**NPDES PERMIT FACT SHEET  
INDIVIDUAL INDUSTRIAL WASTE (IW)  
AND IW STORMWATER**

Application No. PA0264113  
APS ID 877638  
Authorization ID 1085086

Applicant Name	<u>Salvatore &amp; Dianna Tresco &amp; Tresco Concrete Products Inc. Joint Client</u>	Facility Name	<u>Tresco Paving Asphalt Supply</u>
Applicant Address	<u>415 Unity Center Road Pittsburgh, PA 15239-3409</u>	Facility Address	<u>155 Plant Road Delmont, PA 15626</u>
Applicant Contact	<u>Vince Tresco</u>	Facility Contact	<u>Vince Tresco</u>
Applicant Phone	<u>(412) 793-4385</u>	Facility Phone	<u>(412) 793-4385</u>
Client ID	<u>321717</u>	Site ID	<u>464809</u>
SIC Code	<u>2951,3273</u>	Municipality	<u>Salem Township</u>
SIC Description	<u>Manufacturing - Asphalt Paving Mixtures And Blocks, Manufacturing - Ready-Mixed Concrete</u>	County	<u>Westmoreland</u>
Date Application Received	<u>July 17, 2015</u>	EPA Waived?	<u>Yes</u>
Date Application Accepted	<u>April 12, 2018</u>	If No, Reason	<u></u>
Purpose of Application	<u>New request for NPDES permit for Stormwater discharge to HQ-CWF receiving waters</u>

Figure 1: Tresco Site Plan Showing the four Outfalls, One Concrete and Two Asphalt Batch Plants

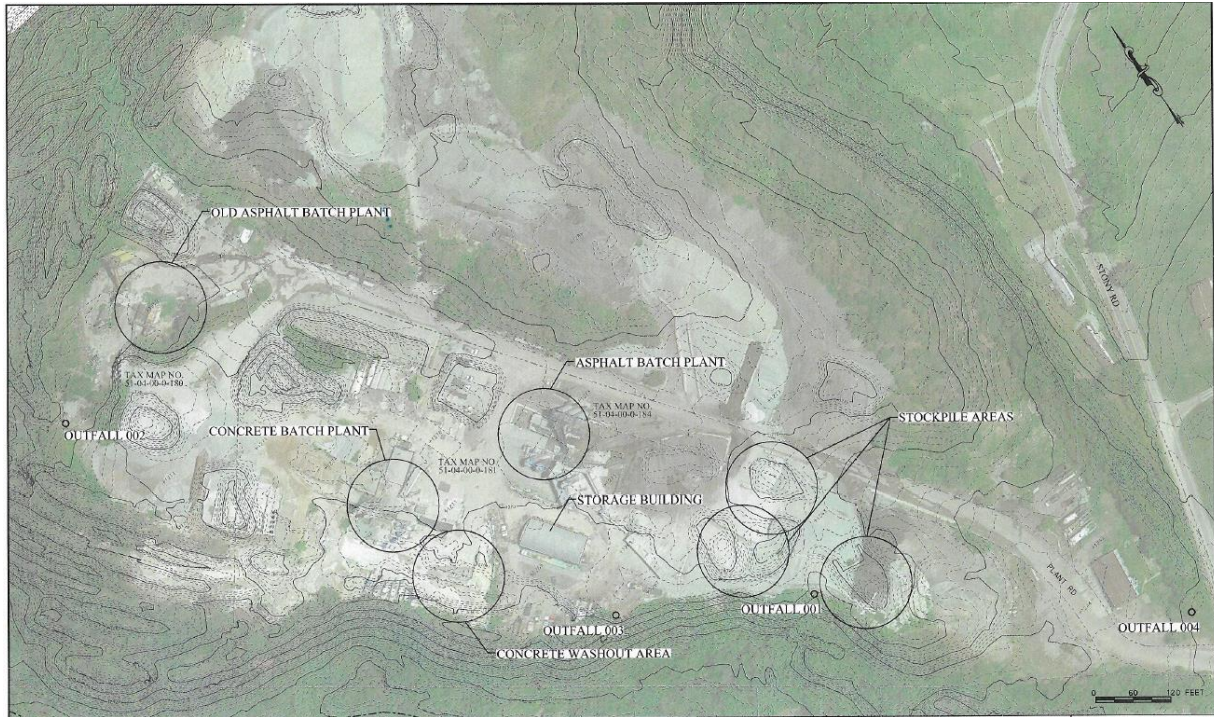
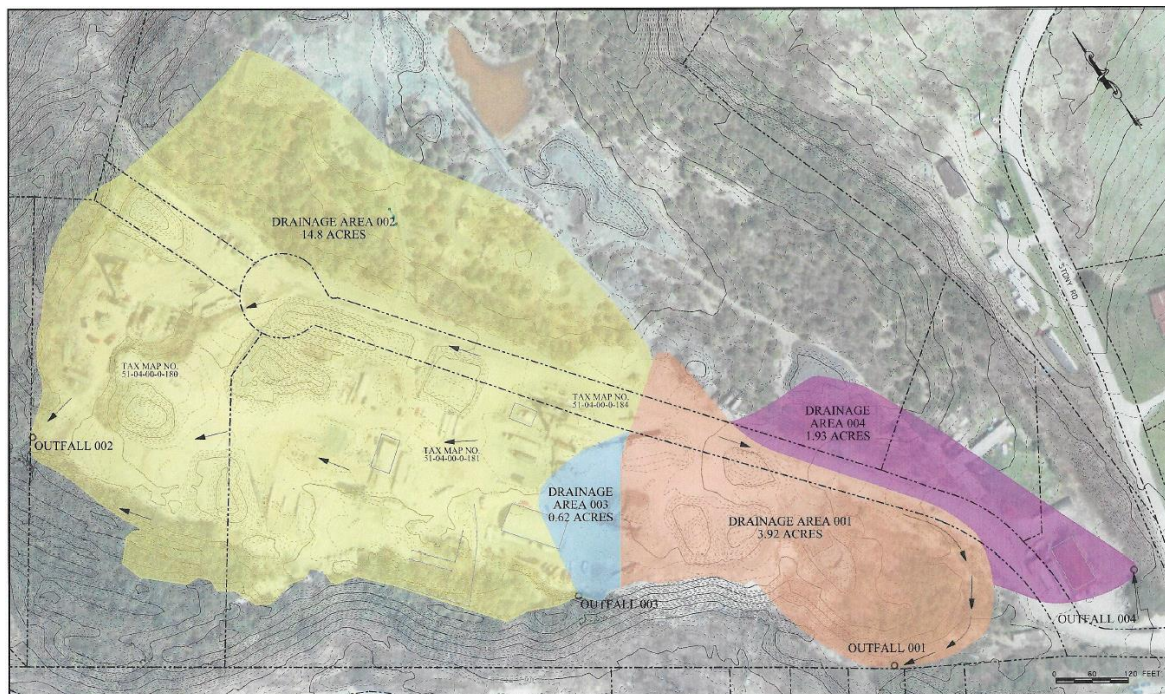
A comparison of Figures 1 and 2 reveals that the three onsite batch plants are located in the drainage area of Outfall 002. Unusually, Outfall 002 does not discharge to a surface water and it is unclear if this discharge enters any of the nearby surface waters. It acts similarly to a detention pond best management practice (BMP), in that, water pools in this location briefly and then infiltrates.

Figure 4: eMapPA Image of the Tresco Site and Environs

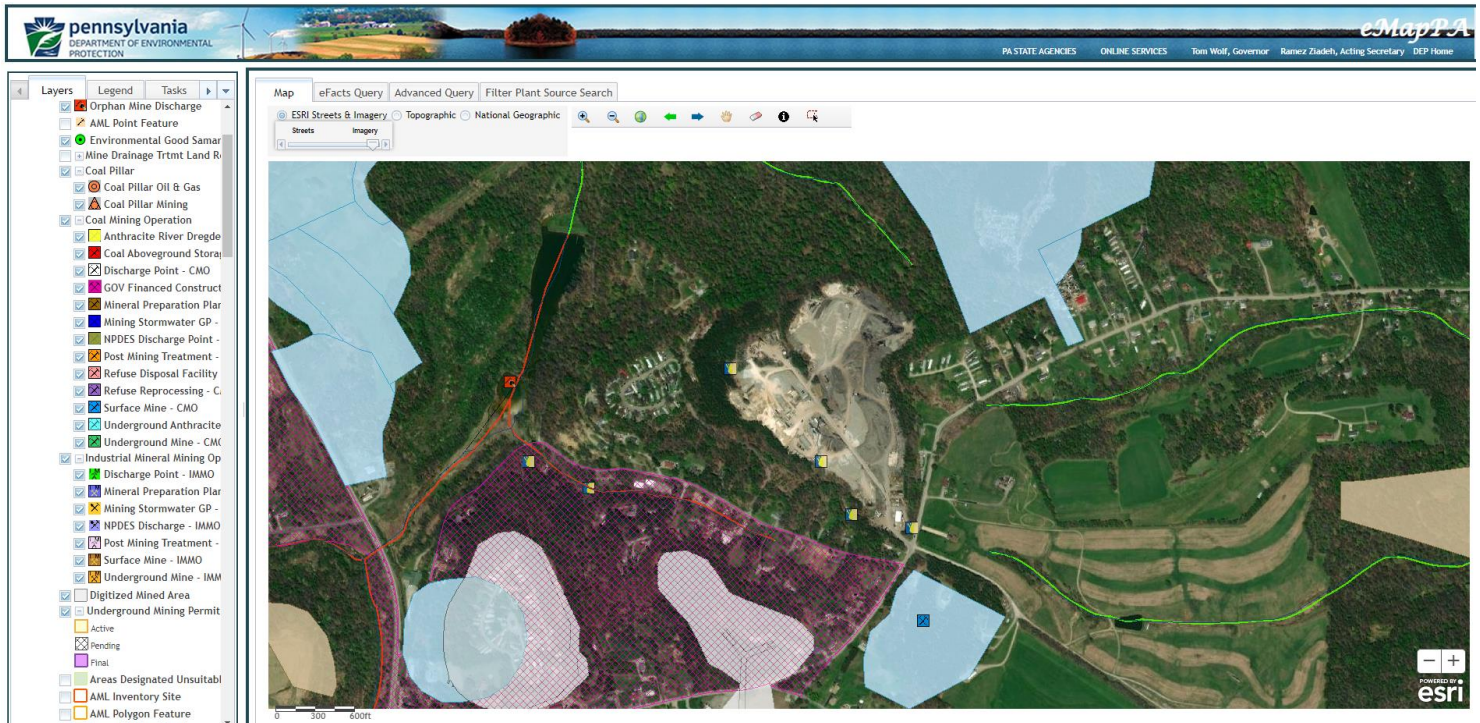
Figure 4 shows the surface and underground mines near the heart-shaped Tresco site in the center of the image. The light blue areas are surface coal mines and the magenta hatched areas are subsurface mines and the partial legend is toward the left of the image. The older surface mine that envelopes today's Tresco site predates these permitted mines. As can be seen in the image, no subsurface mine is directly below the Tresco site. The question of the destination of the discharge from Outfall 002 after it infiltrates has one or more of three obvious possibilities: (1) to a subterranean aquifer, (2) into a mine pool or (3) into a geologic sink. The last of these, a geologic sink is defined as a depression within an endoreic basin (i.e. a basin that retains water and allows no outflow to other external bodies of water). Of note, directly to the west of the Tresco site is a red square on Thorn Run which represents an orphan mine discharge. Directly down stream of this discharge is an abandoned mine discharge treatment area.

As noted above, all the industrial processing areas for the two asphalt plants and one concrete plant are located within the drainage area designated as Outfall 002. This area has no observable discharge to surface waters, but to firmly establish whether any of the drainage ultimately makes its way to surface water, further study would be required. Absent additional geologic information, the discharges to 002 will be regulated as surface water discharges to ensure that ground and surface water resources are protected from contamination.

Figure 5: Drainage Area at the Headwaters of UNT 42990 of Thorn Run and Location of Outfall 001

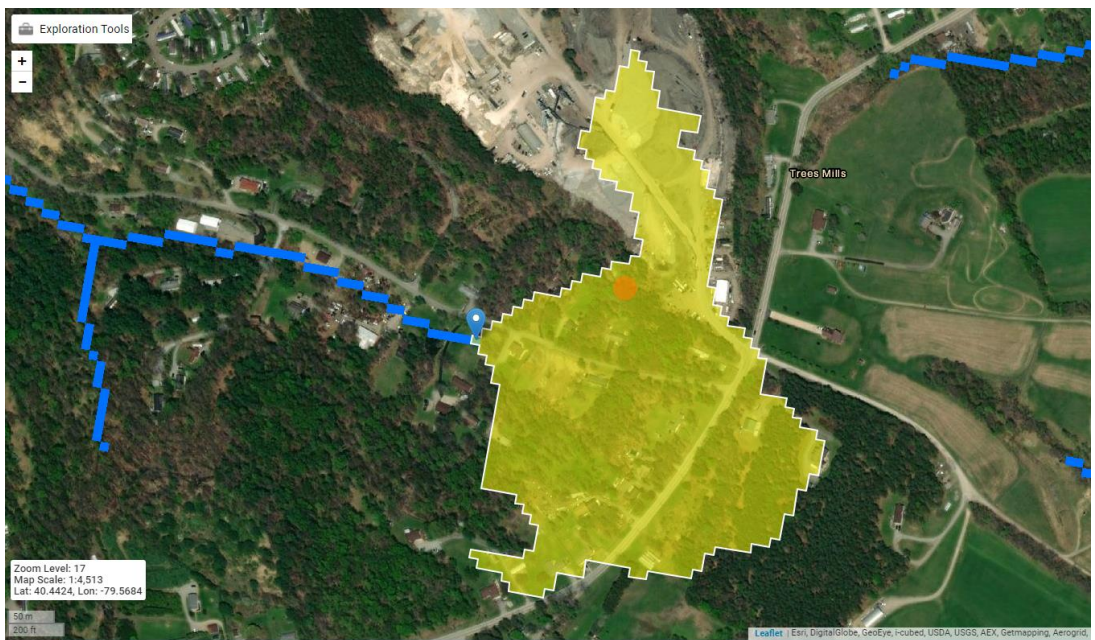
Other Comments: As can be seen from Figure 5, Outfall 001 is in the headwaters of UNT 42990, as is Outfall 003.

**Figure 7: Topographic Map of Tresco Outfall 002 and the Orphan Mine Discharge on Thorn Run**

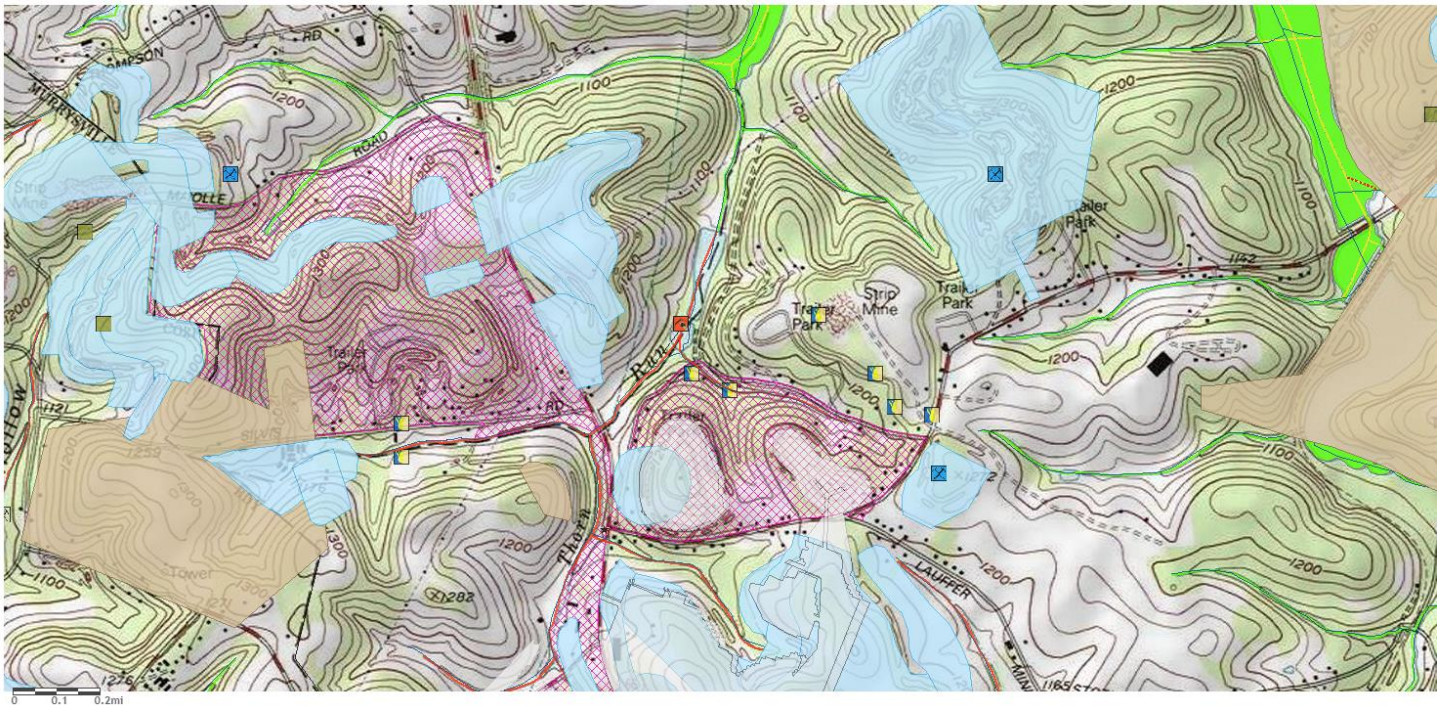
Because of proximity and topography, this discharge is expected to drain into the adjacent Thorn Run watershed, likely through a segment of the underground mine pool to the south of the Tresco site. Note that Pennsylvania's Clean Streams Law broadly defines groundwater and mine pools as waters of the Commonwealth and therefore are subject to regulation. Should it be determined in the future that stormwater settling in the vicinity of Outfall 002 does not make its way to regulated waters (e.g. is to a geologic sink) then this decision may be reconsidered. Figure 7 is a topographic map view from eMapPA, similar to that previously shown in Figure 4, but centered on the orphan mine discharge on Thorn Run:

The red square in the center of Figure 6 is the location of the orphan mine discharge, as well as, other outfalls from the underground mine directly south of the Tresco site. A careful study of this figure reveals that the elevation at the Outfall 002 location is notably higher than both the mine to the south and the various outfalls toward the southeast on Thorn Run. Given this, the Department considers that the most reasonable approach is essentially the same as used for Outfalls 001 and 003. This will require that a provision be implemented to collect a stormwater sample at Outfall 002.
